**MINUTES OF THE 51<sup>st</sup> MEETING OF THE EXPERT GROUP ON ZOO  
DESIGNING OF THE CENTRAL ZOO AUTHORITY HELD ON  
5<sup>th</sup> June, 2014**

Project- **MINI ZOO-PIPLI**

Job Title- REVISED  
**LEOPARD ENCLOSURE**  
 LAYOUT PLAN

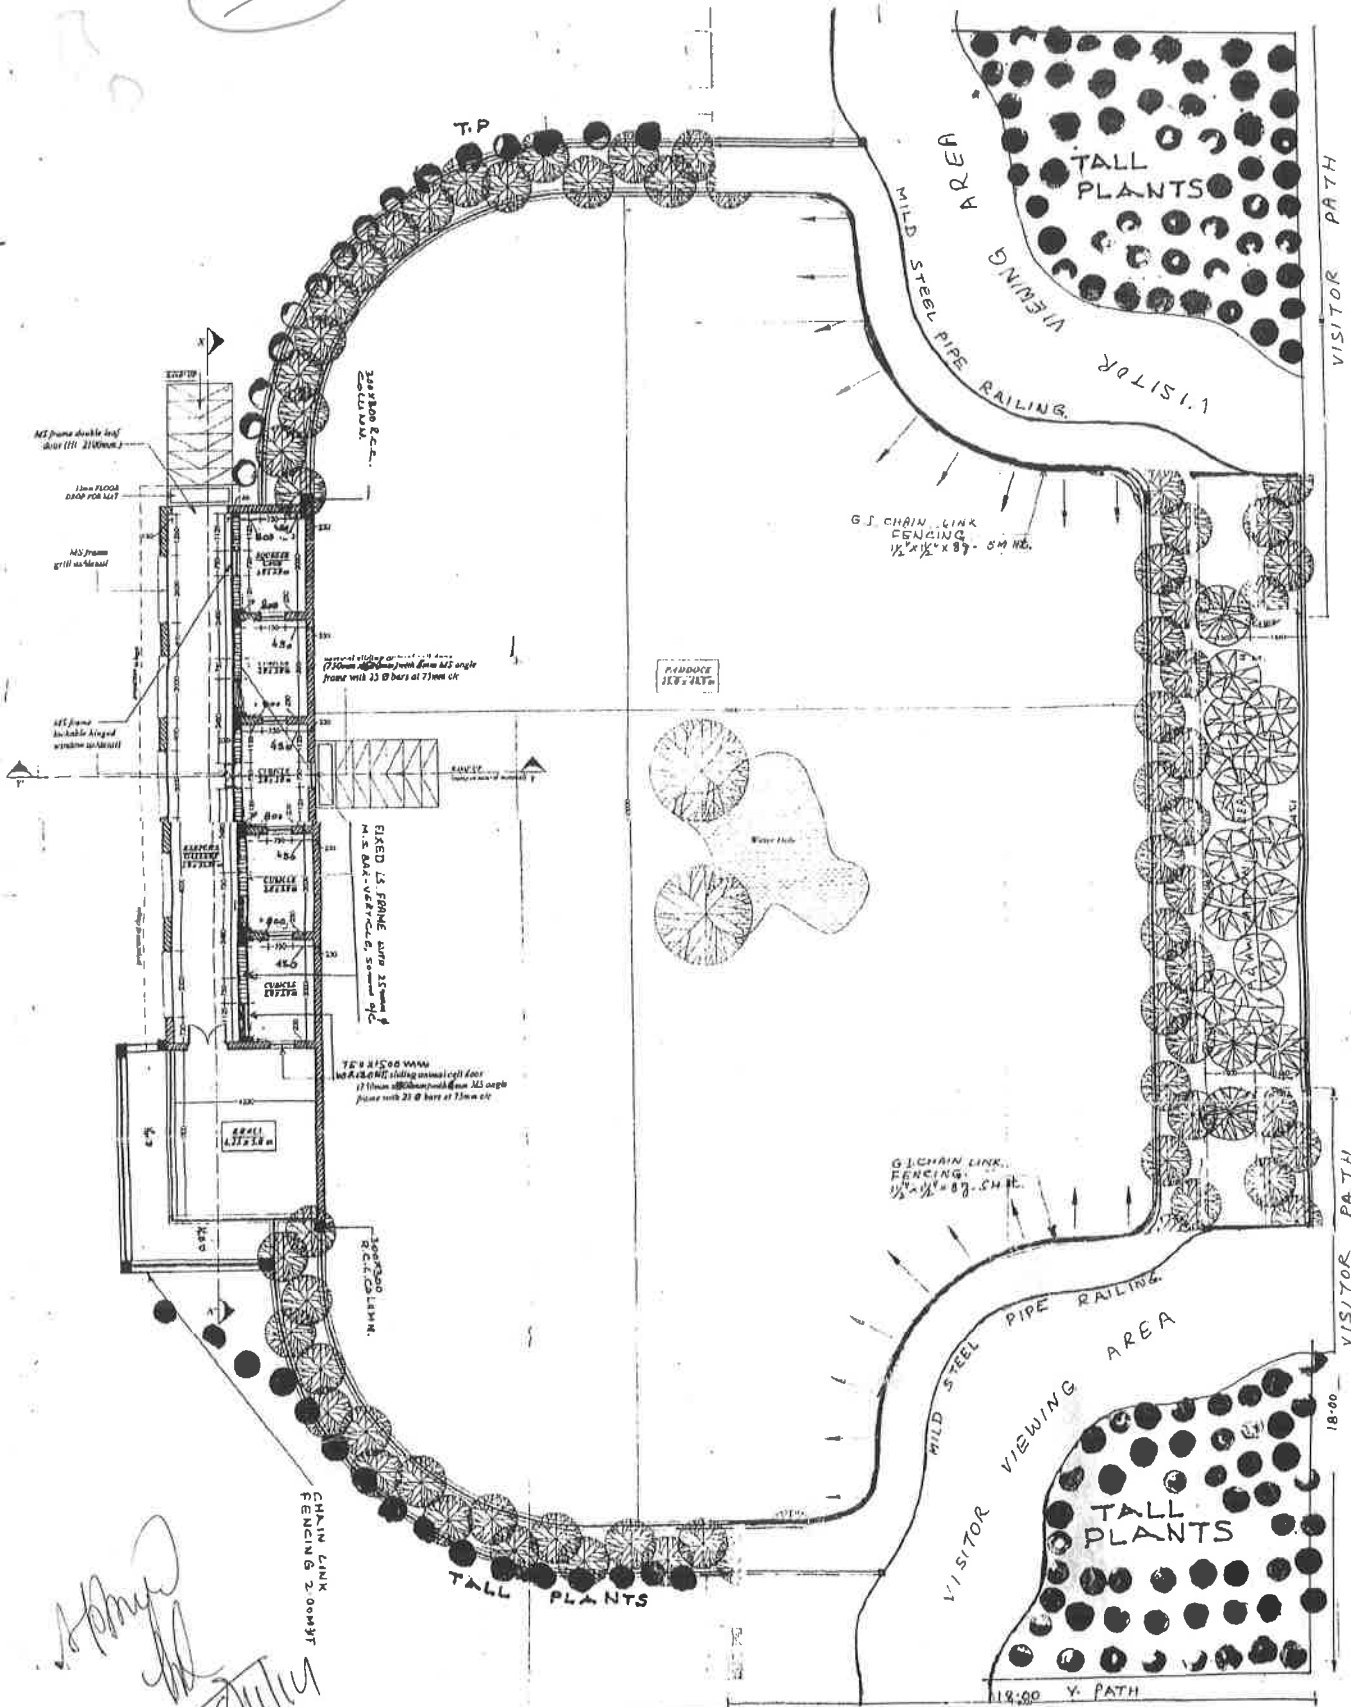
a. Leopard enclosure

The drawing has been seen earlier and a few changes were suggested. The zoo authorities should follow that changes.
